SUBJECT: SAFETY RECALL OF 2026 MB TOURRIDER COACHES

Ref.: NHTSA recall reference # 26V-063
DCNA Bulletin # **TI 72.40U26365A**

TI No.: 72.40U26365A

TITLE: **External emergency valve not working**

M72.10-0219-78

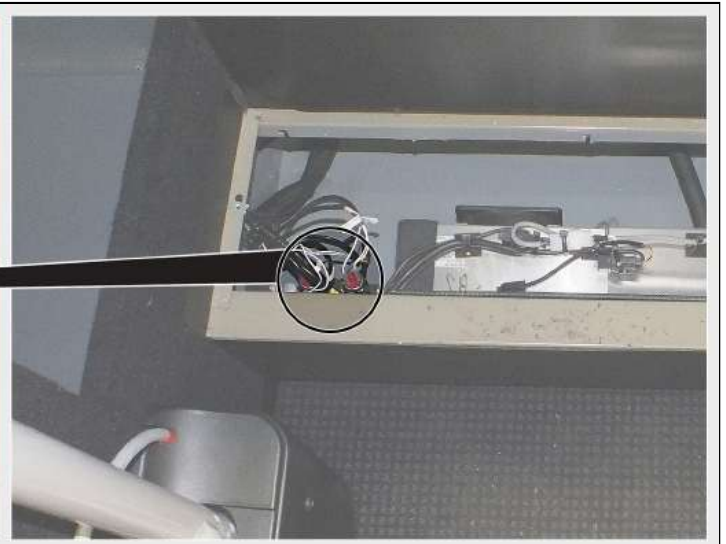
Door control valve of passenger door 1

1. Remove or fold open the cover in front of door control valve **(1)**.

M72.40-0042-78

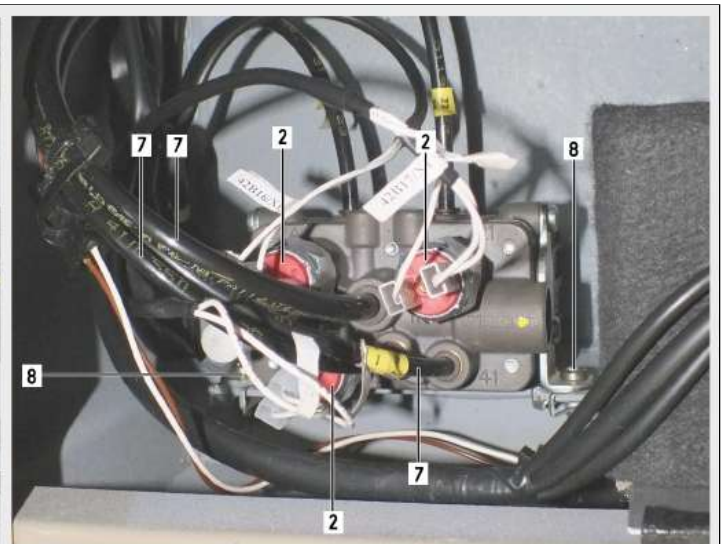
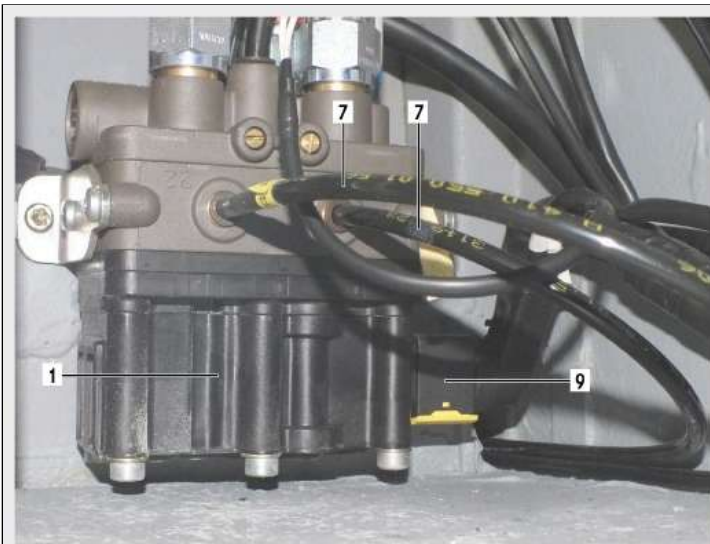
1. Unscrew screws **(6)** and remove the step cover.

M72.40-0043-78

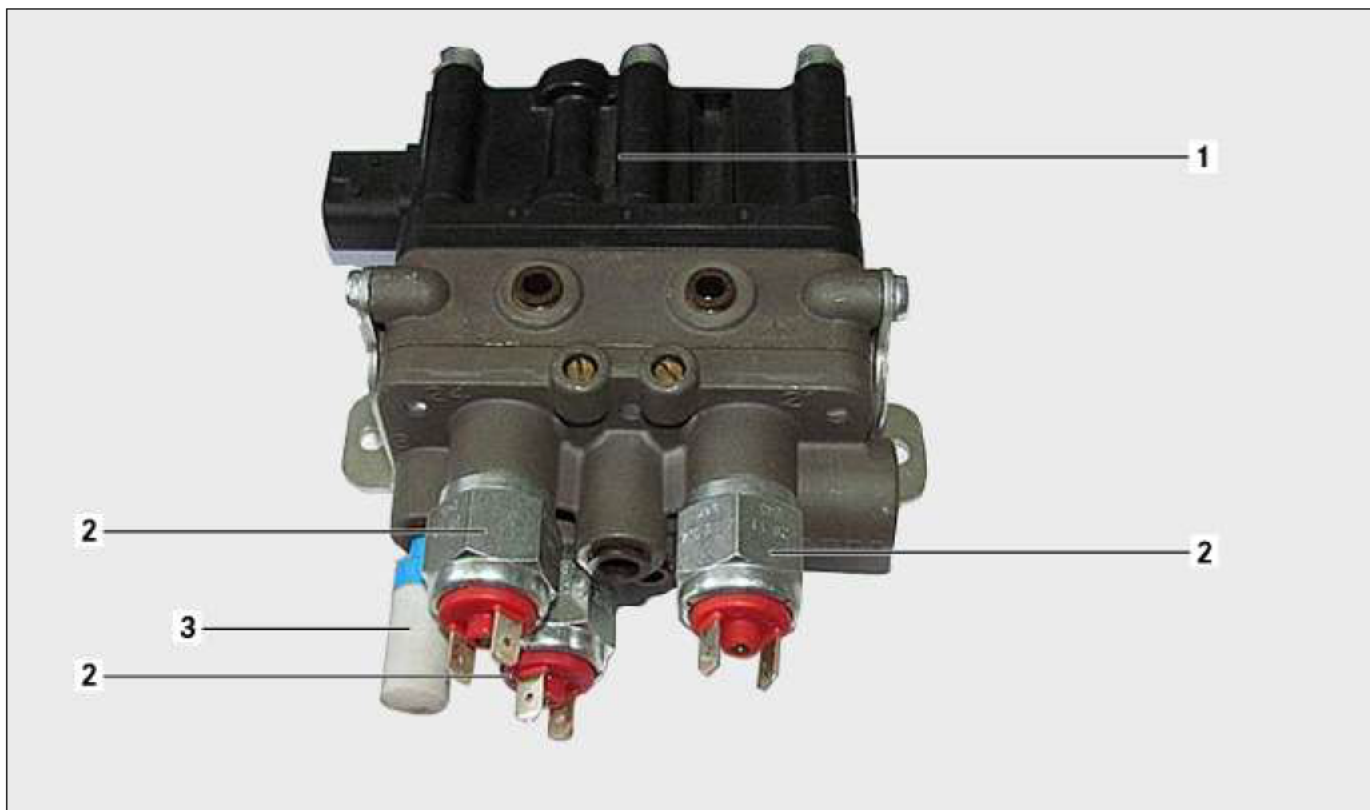
1. Label and disconnect electrical **(2)** and pneumatic **(7)** lines.
2. Unscrew screws **(8)**.
3. Release and disconnect electrical connection **(9)**.

M72,40-0037-75

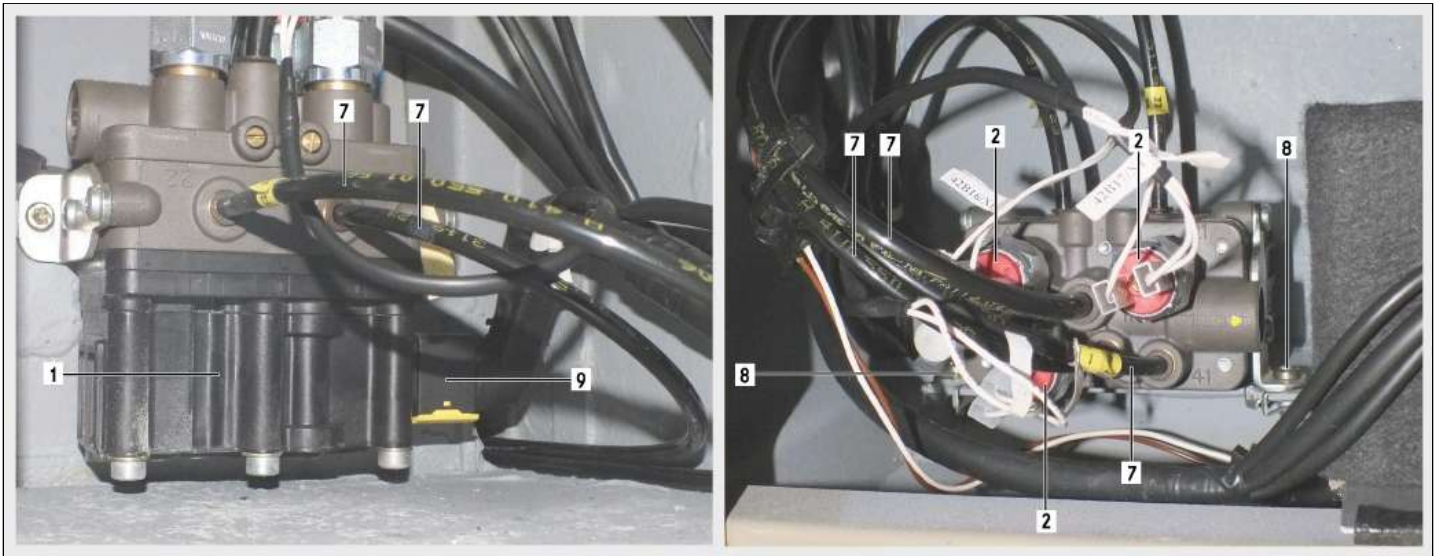
1. Remove pressure switches **(2)** and fit them to new door control valve **(1)**.

Tightening torque

Pressure switch to door control valve

30 Nm

Replace sealing rings with new ones.

2. Remove silencer **(3)** and fit it to new door control valve **(1)**.

M72.40-0043-78

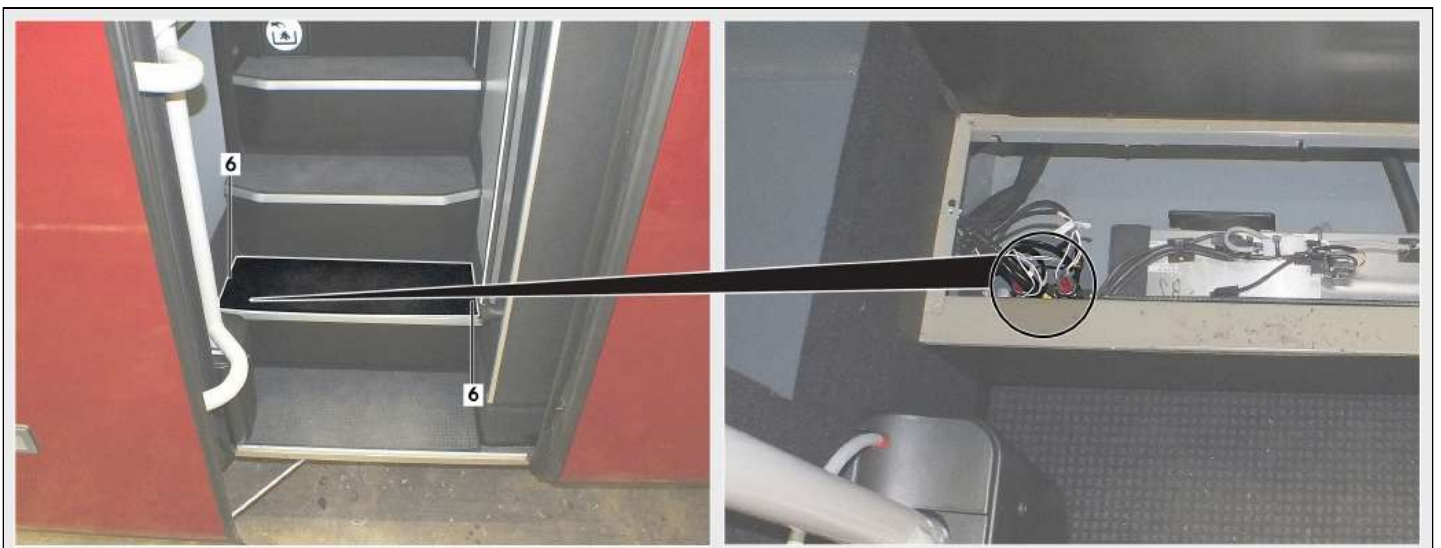
1. Note: [Routing of lines](#)
2. Establish and engage electrical connection **(9)**.
3. Fasten door control valve **(1)** in place using screws **(8)**.
4. Connect pneumatic lines **(7)** to door control valve **(1)**.

Observe the markings, do not misconnect pneumatic lines **(7)** under any circumstances.

5. Connect the electrical lines to the connections of pressure switches **(2)**.

Observe the markings, do not misconnect the electrical lines under any circumstances.
